CERTIFICATE OF APPROPRIATENESS PLACARD

223 ELM STREET

119-15-MW

Raleigh Historic Development Commission – Certificate of Appropriateness (COA) Application

223 Elm St - New Rear Elevation

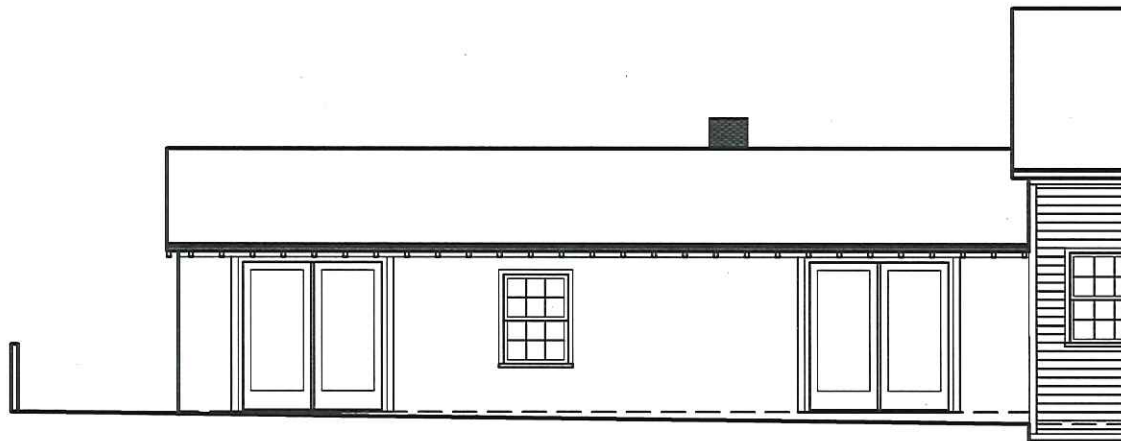
New window
and new wood
deck landing.

Removed non-historic
masonry flue

223 Elm St - New Driveway Side Elevation

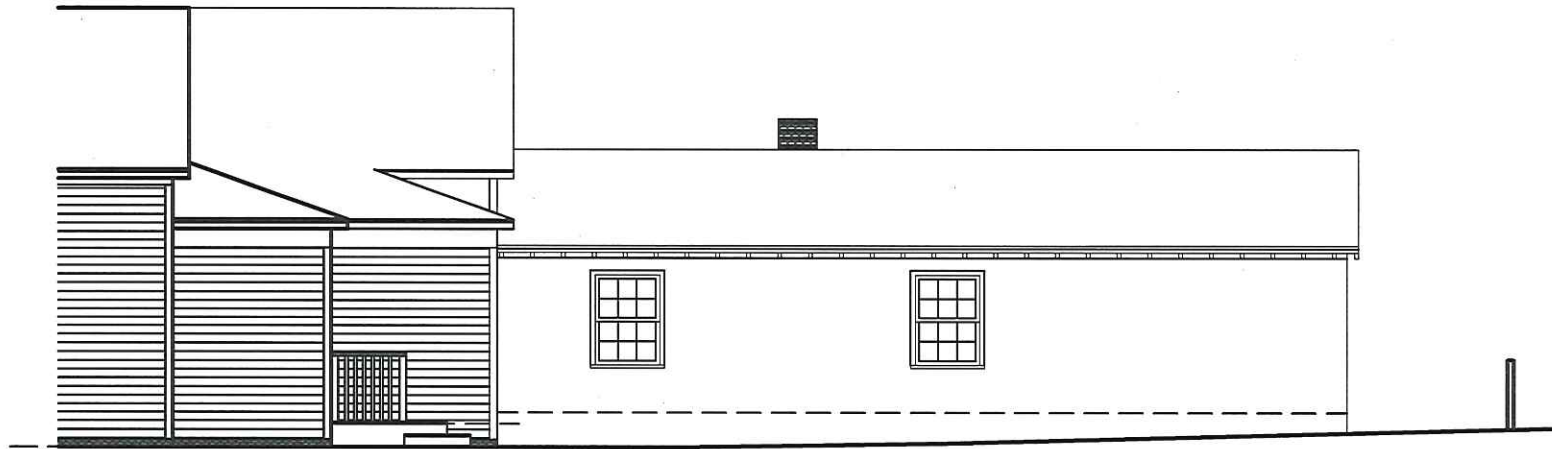
New wood window to be consistent with wood windows on addition. Sill to be raised + parge coated.

223 Elm St - New Patio Side Elevation

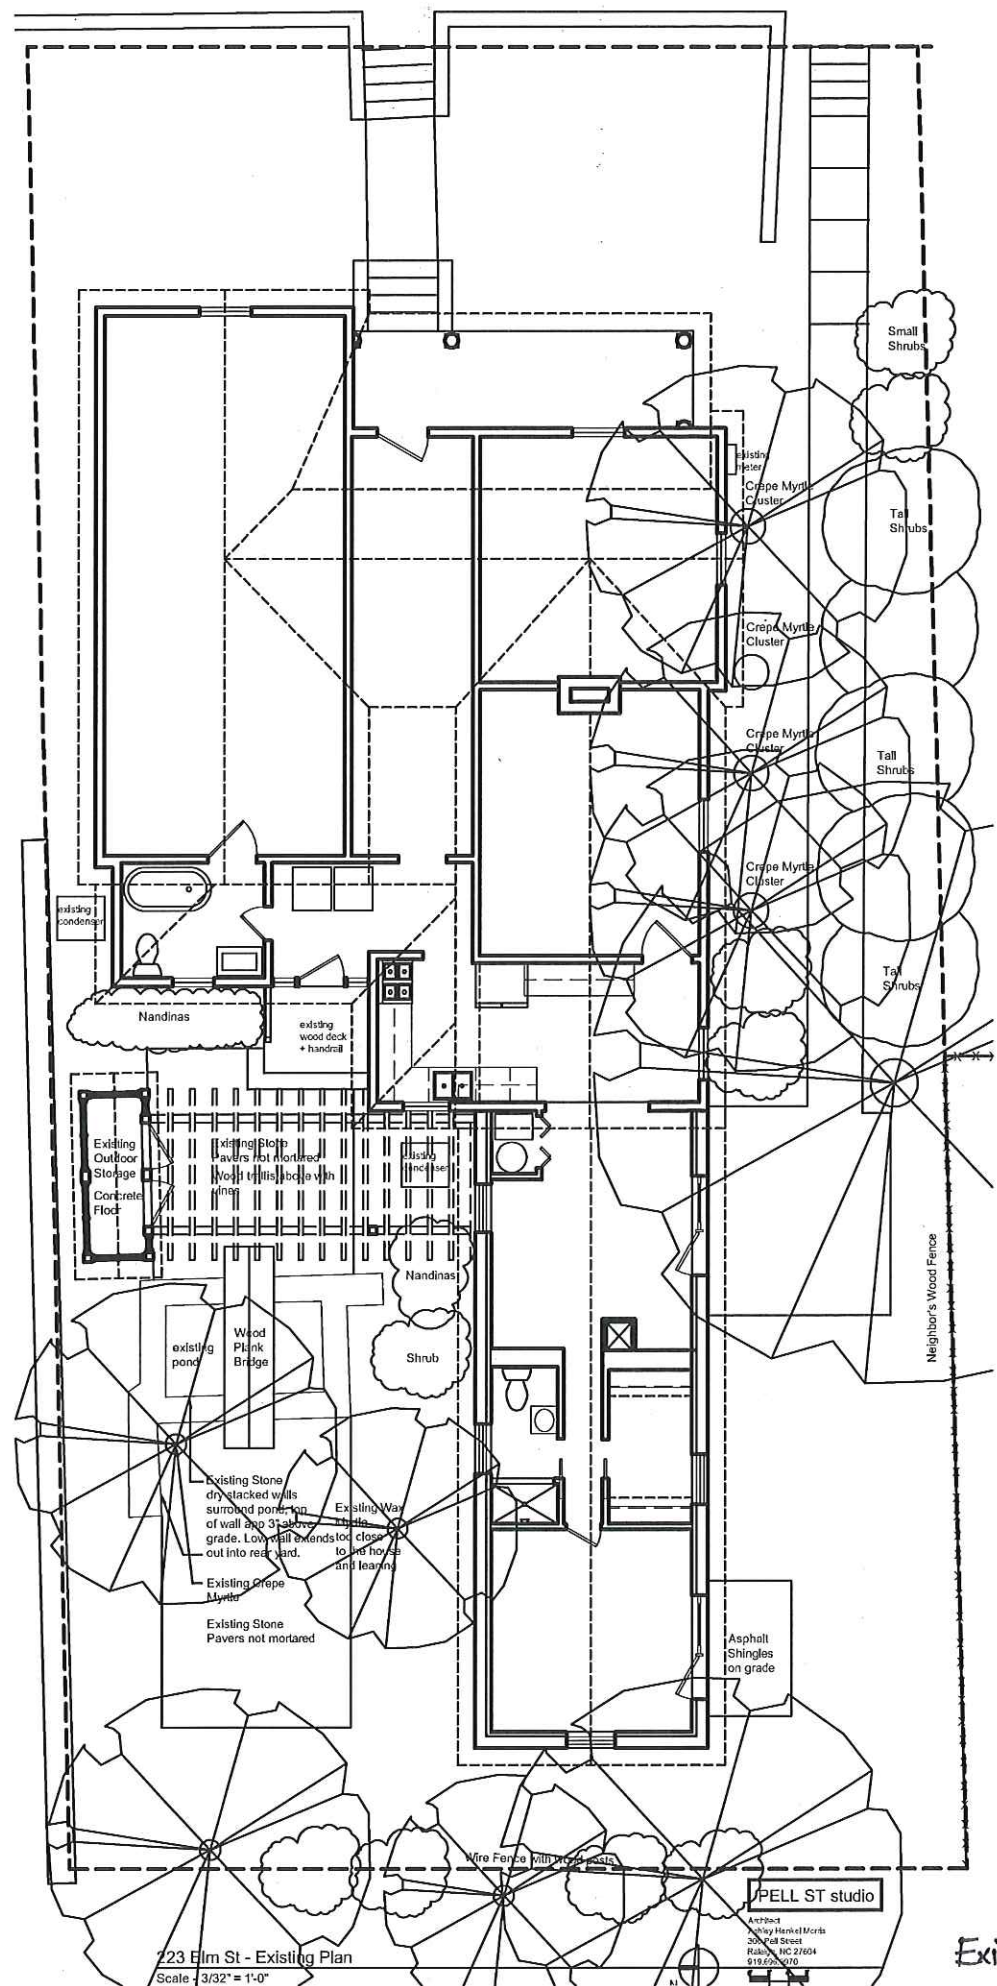
New wood full lite door and new wood deck landing.

223 Elm St - New Plan
Scale - 3/32" = 1'-0"

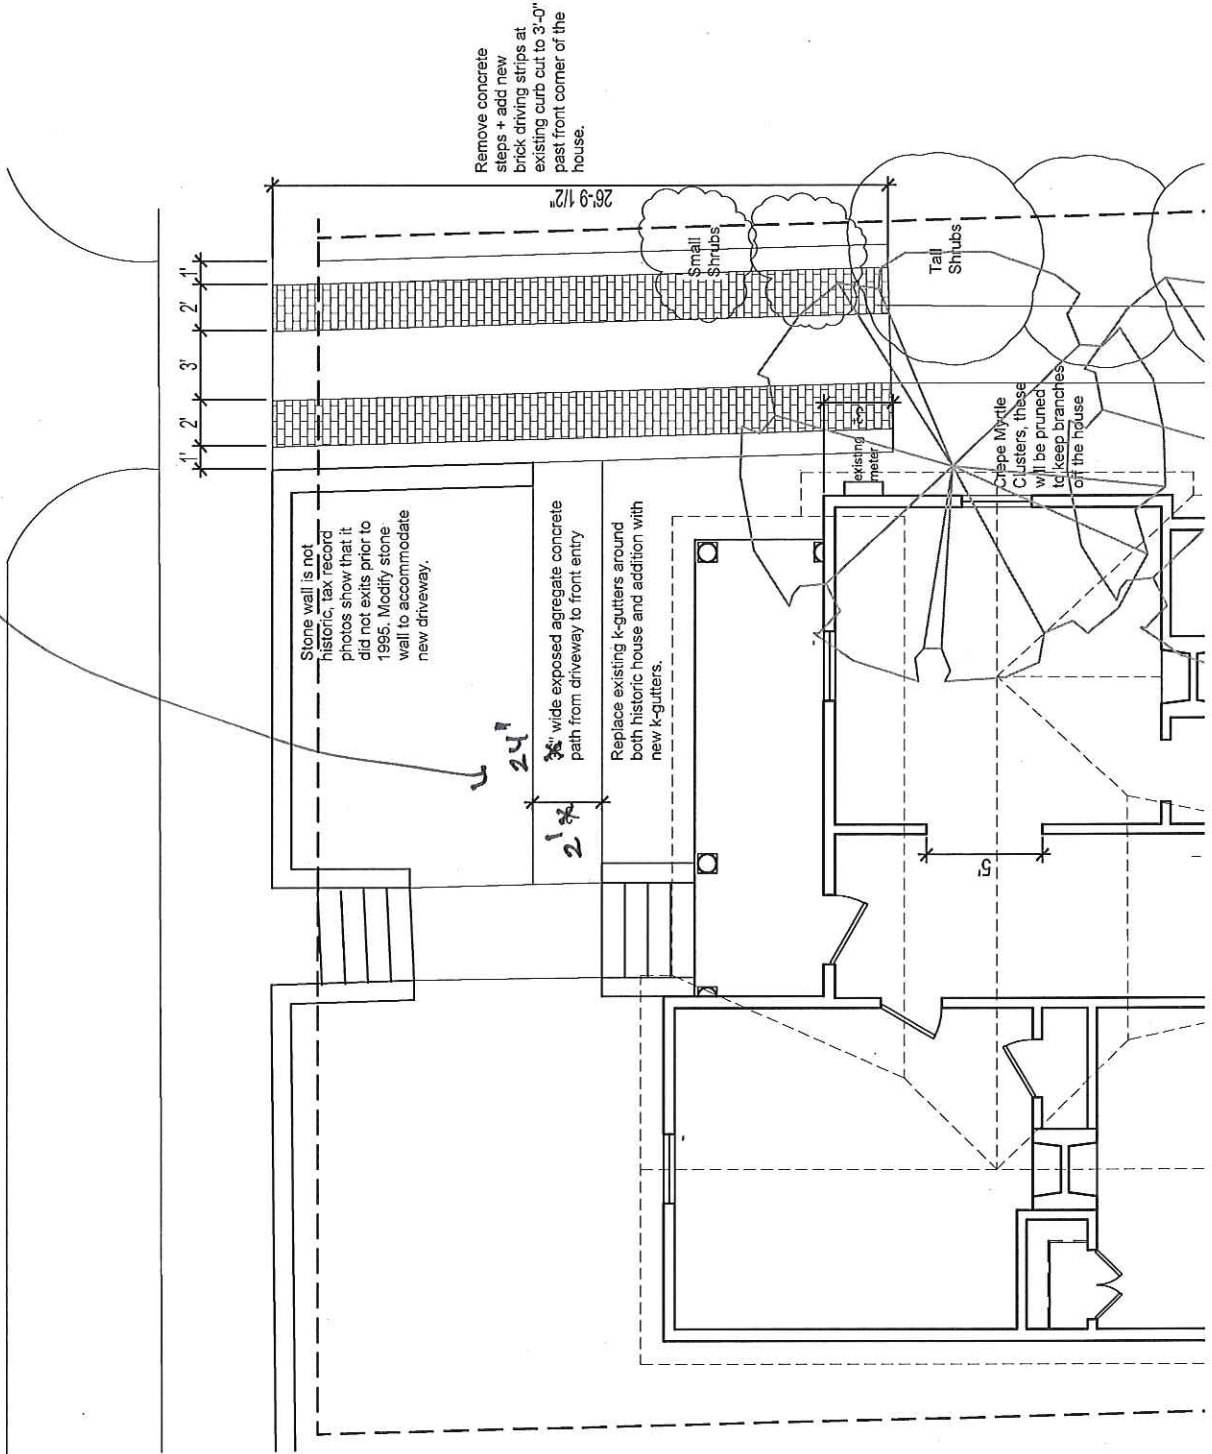
3. Please provide section drawing for door.
4. OK
5. The proposed site plan still notes that crape myrtle trees and a Wax Myrtle tree are to be removed. Please submit revised drawing.

6. OK
7. Per the Guidelines and confirmed with recent COA decisions, the driveway needs to have a driving strip appearance. Solid concrete is not approvable by staff. Typically this involves 2 to 2-1/2 foot running strips with 3' between. Please provide a larger scale drawing with dimensions. The adjacent driveway at 221 Elm Street was approved under the prior set of Design Guidelines.

- ✓3. Attached is the section for the wood full lite door into the kitchen.
- ✓5. Updated site plan attached. The home owners would also like to match the fence at 221 Elm St aesthetic and materials but will be 42" tall. This is noted on the site plan with a gate and a photo of the neighboring gate and fence that the new will match.

- ✓7. Attached is the updated plan for the driveway and the new site plan shows it as well.
- ✓9. It will be infilled with soil and an annual planting bed will be planted.

See revised 8/12/15

223 Elm St - New Plan
Scale - 3/32" = 1'-0"

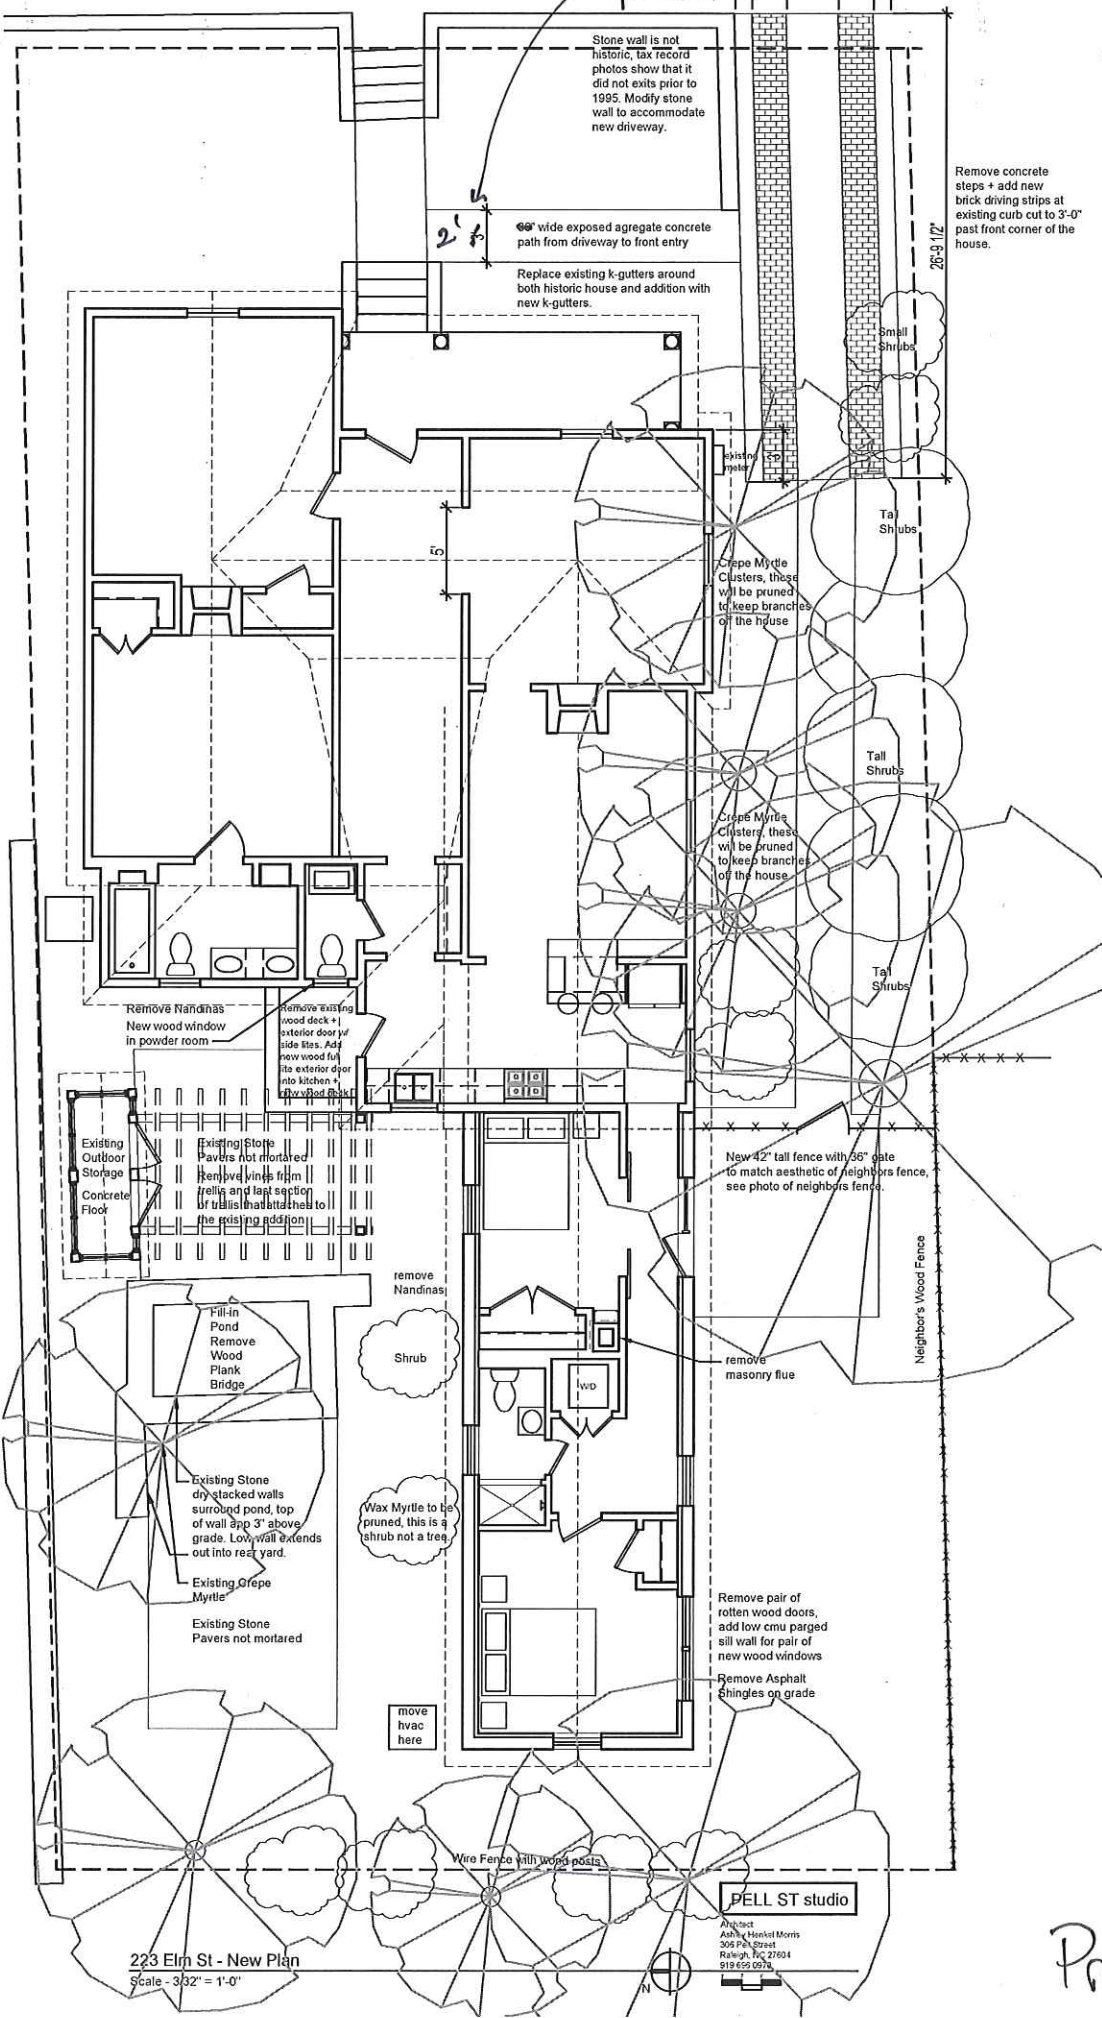
11. What is the dimension of the new walkway? It needs to be subservient to the main front walk, and thus may need to be narrower.
12. I received the color chart & gutter photos.

Revised
8/12/15

Remove concrete steps + add new brick driving strips at existing curb cut to 3'-0" past front corner of the house.

2' f
66" wide exposed aggregate concrete path from driveway to front entry

Crape Myrtle Clusters, these will be pruned to keep branches of the house

Wax Myrtle to be pruned, this is a shrub not a tree

New 42" tall fence with 36" gate to match aesthetic of neighbors fence, see photo of neighbors fence.

VERTICAL SECTION

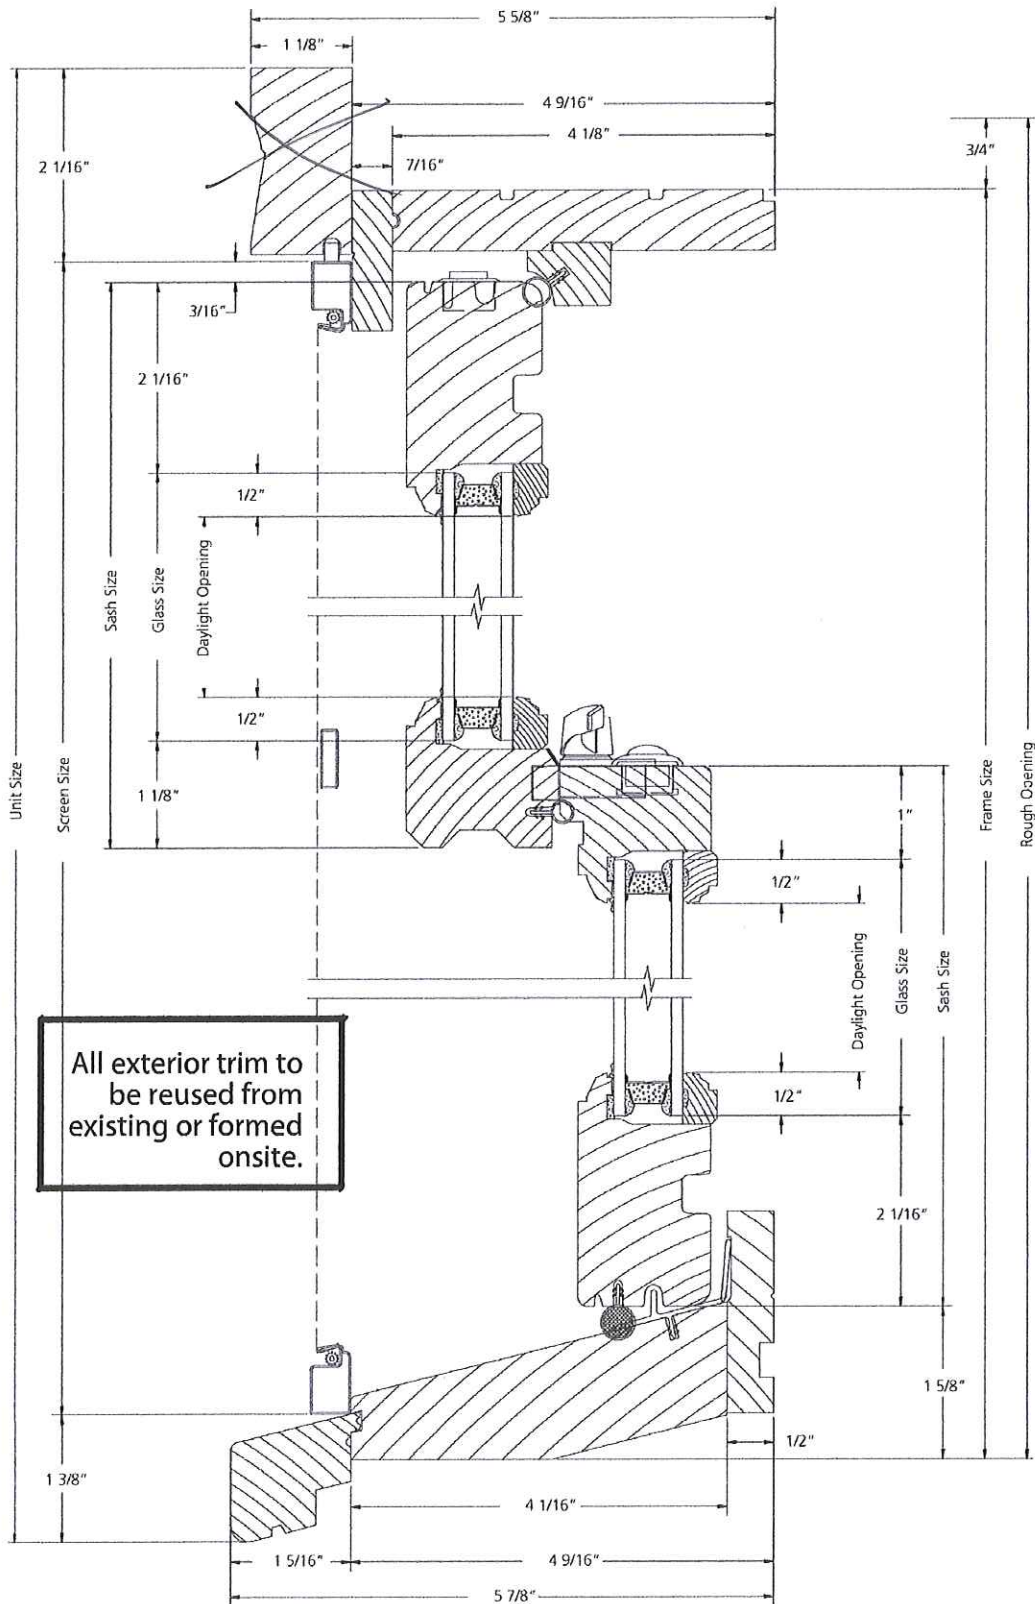
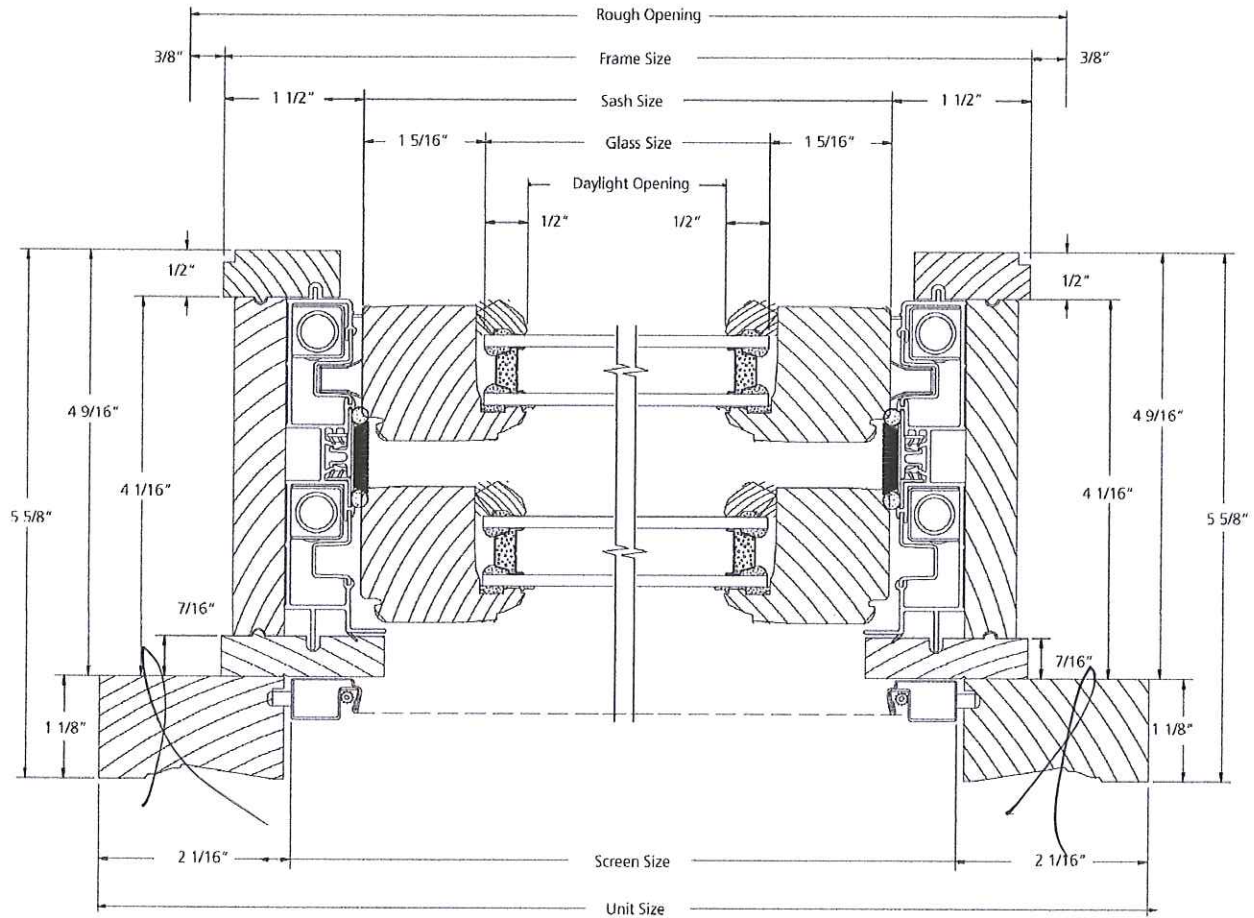
1. There is a note that trim will match existing. Please provide close up photo of trim being matched. Please also provide muntin specifications/sections.

2. Please confirm that the new wood siding will be woven in with the existing so as to avoid matching vertical joints. The awning window specs provided are for aluminum clad wood windows. Please resubmit for wood windows and include muntin specifications/sections.

All exterior trim to be reused from existing or formed onsite.

Exterior trim to be rused
from existing or formed
onsite.
